Point Beach Nuclear Plant, Units 1 and 2
Dockets 50-266 and 50-301
Renewed License Nos. DPR-24 and DPR-27

License Amendment Request 261
Extended Power Uprate
Response to Request for Additional Information

LICENSE AMENDMENT REQUEST 261 EXTENDED POWER UPRATE RESPONSE TO REQUEST FOR ADDITIONAL INFORMATION

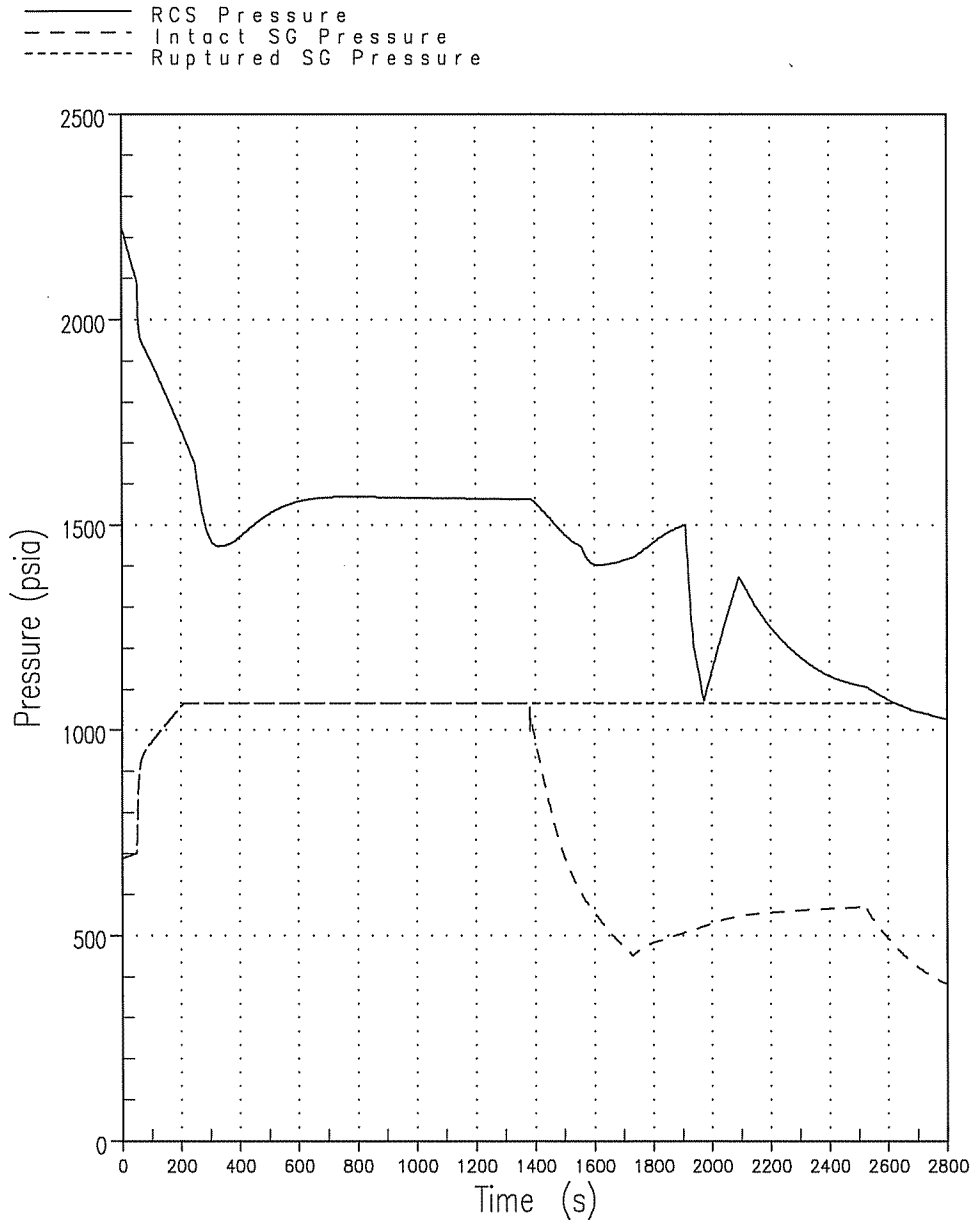
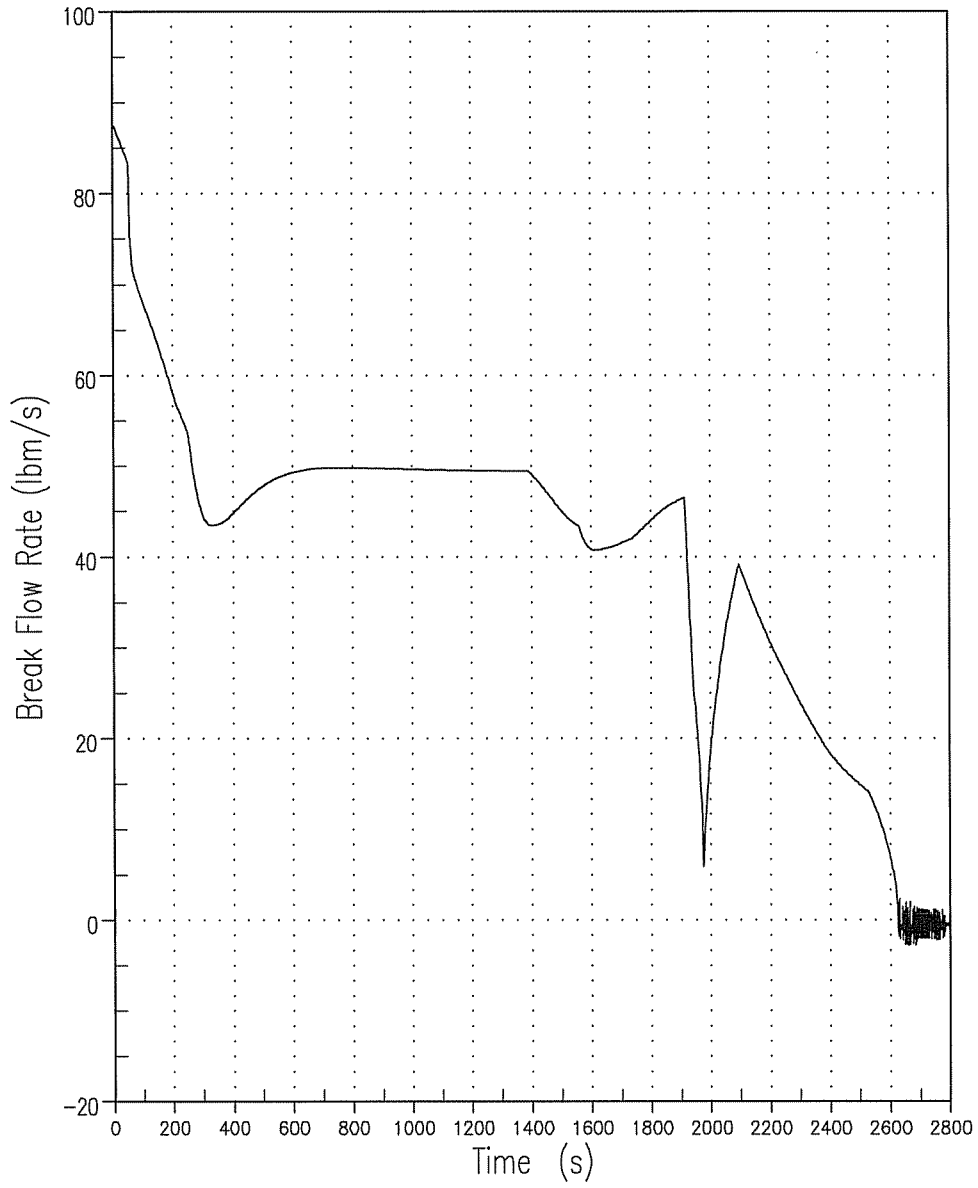
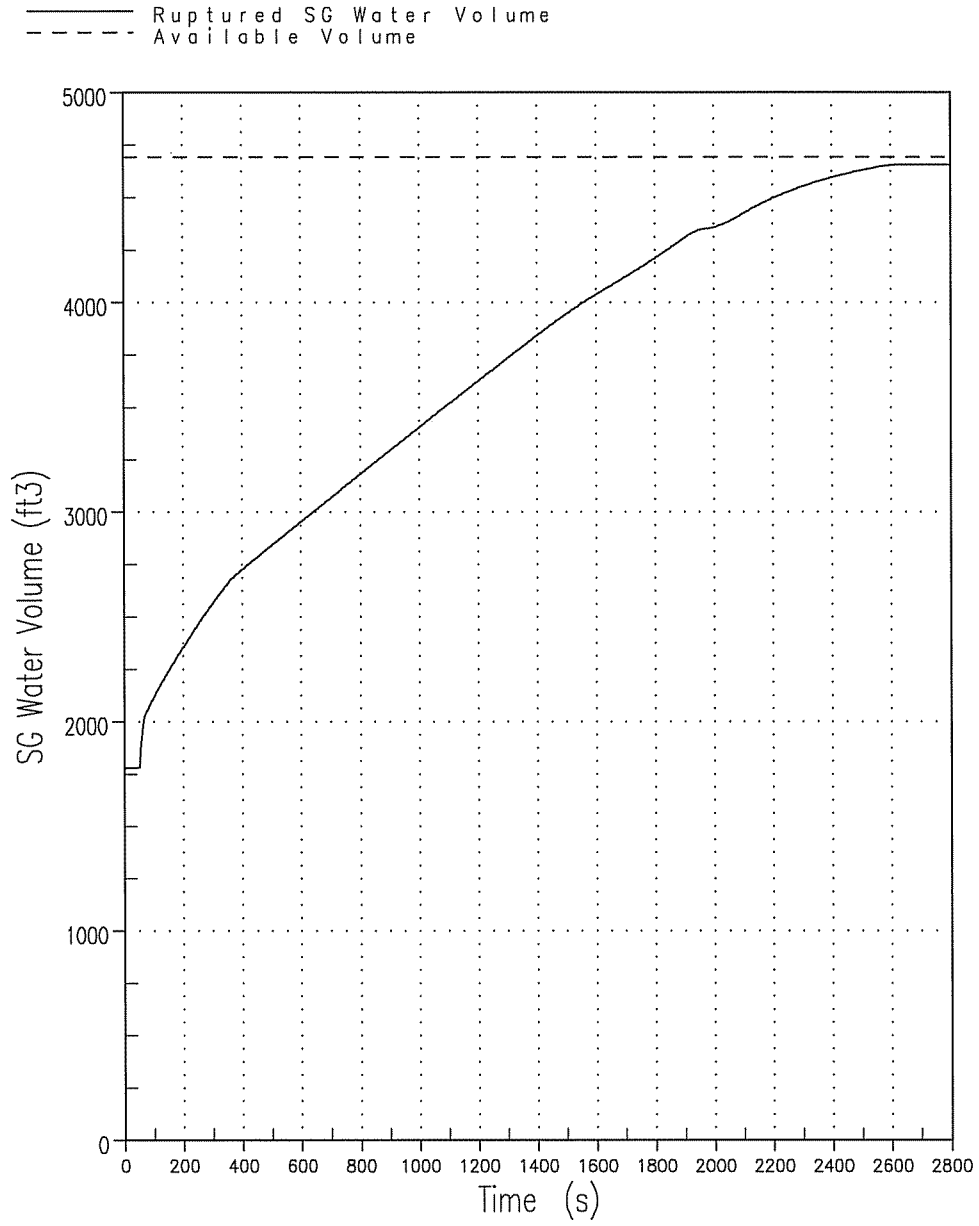
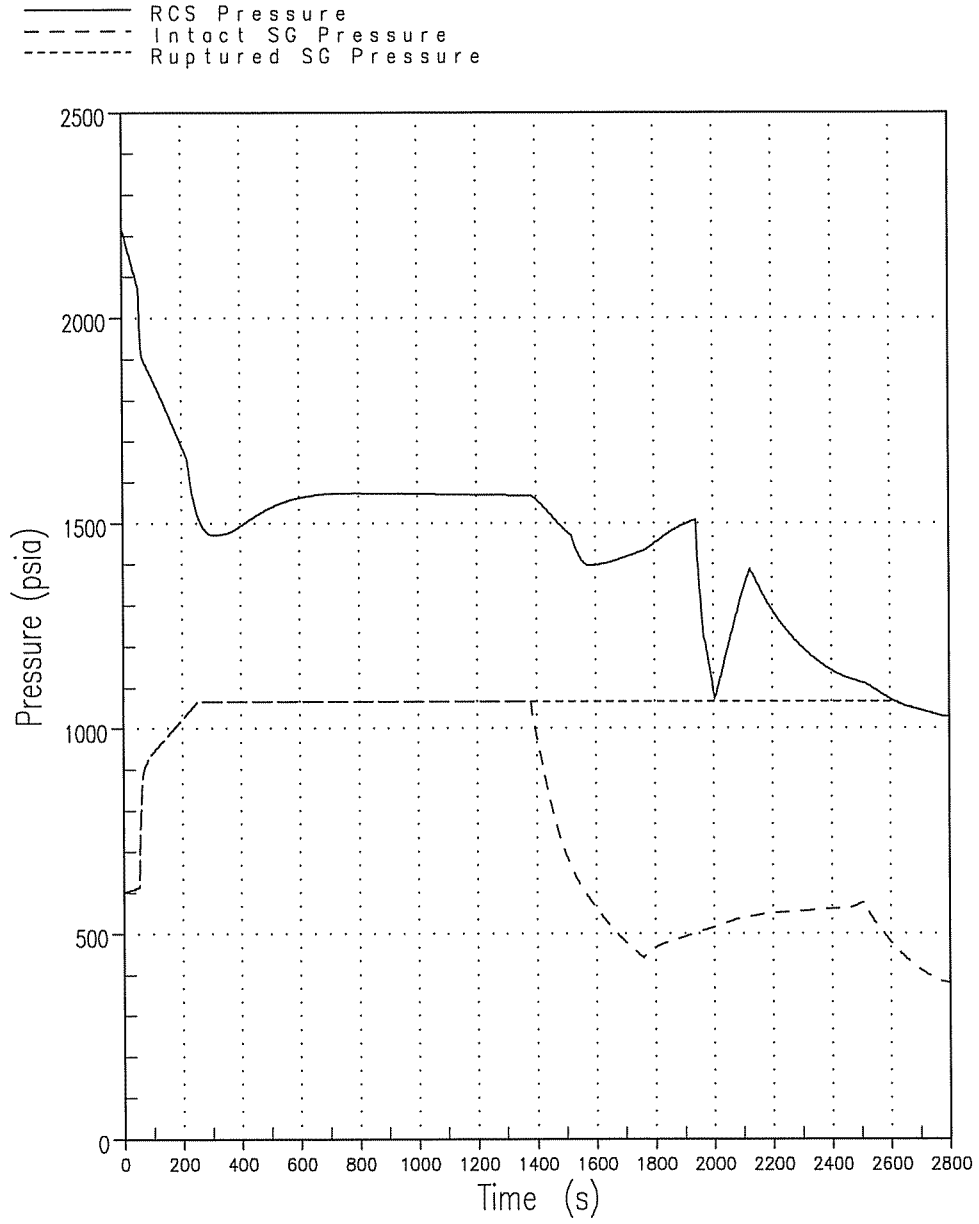
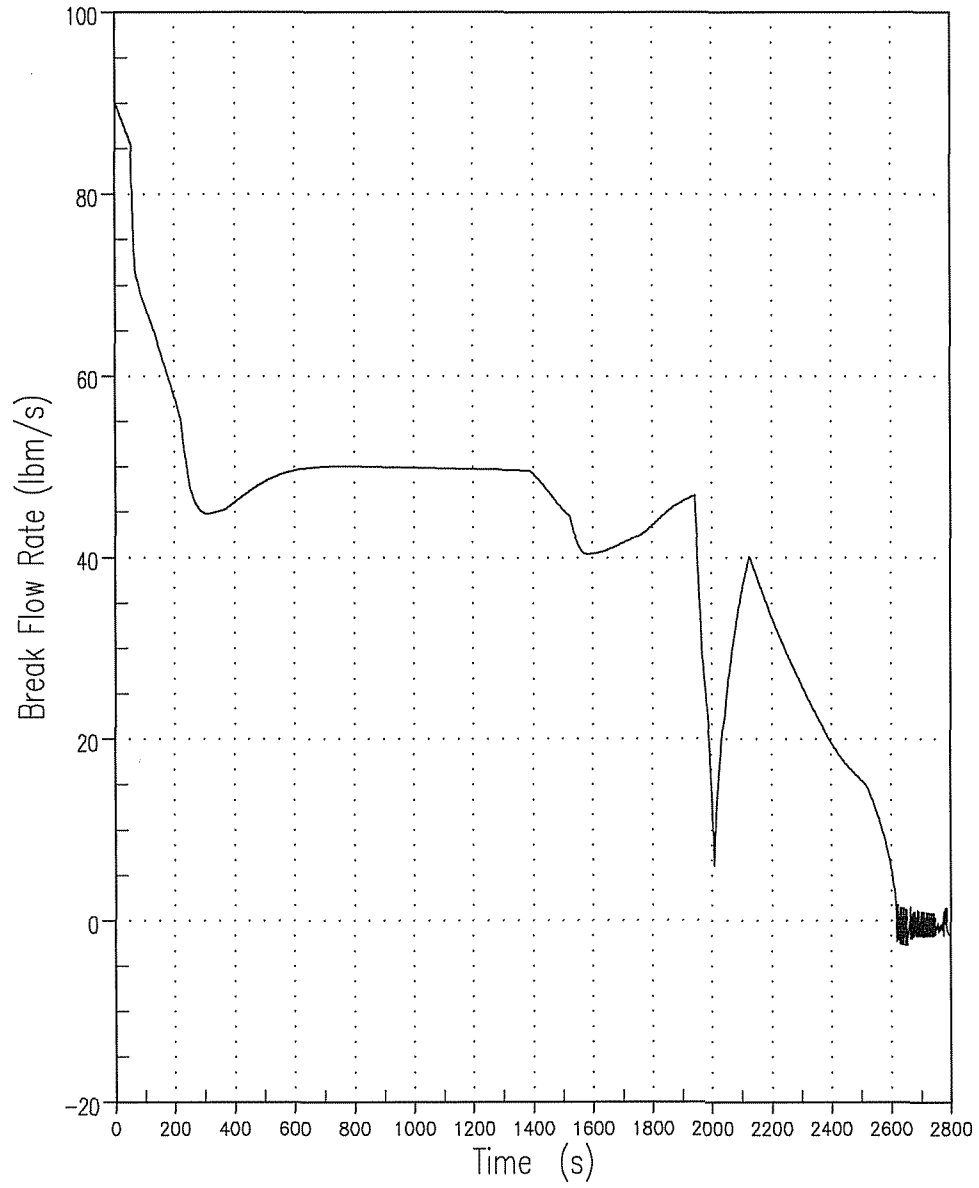
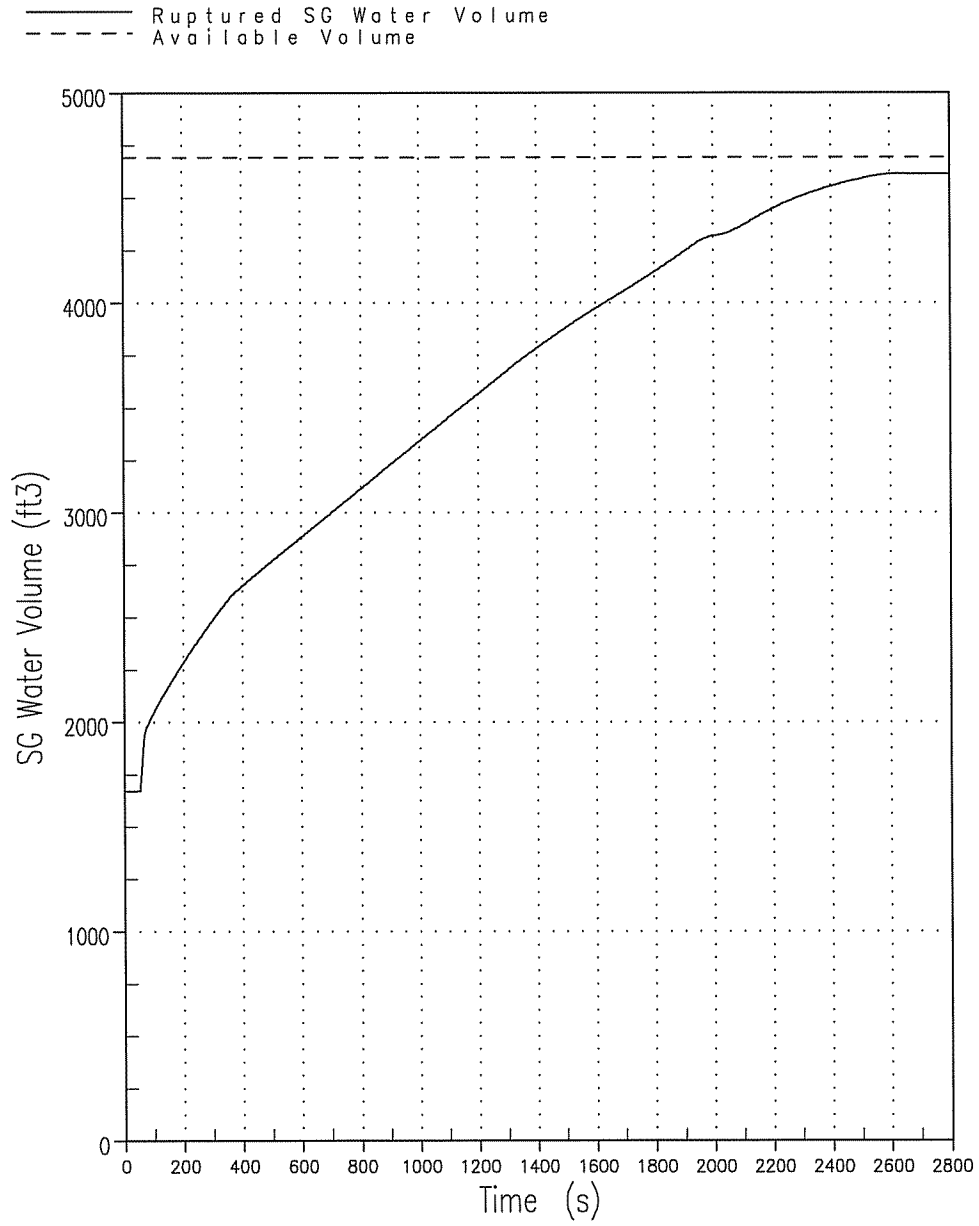
Provide a thermal-hydraulic analysis for PBNP, at both current licensed thermal power conditions and at the proposed, uprated conditions, for a limiting margin-to-overfill/overfill scenario. One acceptable methodology would be for the analysis to align as closely as possible to what is approved in WCAP-10698-P-A; however, since the licensee has asserted that a limiting single failure is not in the Point Beach licensing basis, this exception to the WCAP-10698-P-A methodology would be acceptable.

The results indicate a margin to overfill of >30 ft³ in the ruptured steam generator (SG) for the CLTP case, and >70 ft³ in the ruptured steam generator for the EPU case. No water is transferred into the steam lines. The sequence of events for each analysis is provided in Table 2. Figures 1, 2, and 3 provide the time-dependent primary and secondary pressures, primary-to-secondary break flow, and ruptured steam generator water volume, respectively, for

the limiting CLTP scenario. Figures 4, 5, and 6 provide the same figures for the limiting EPU scenario.
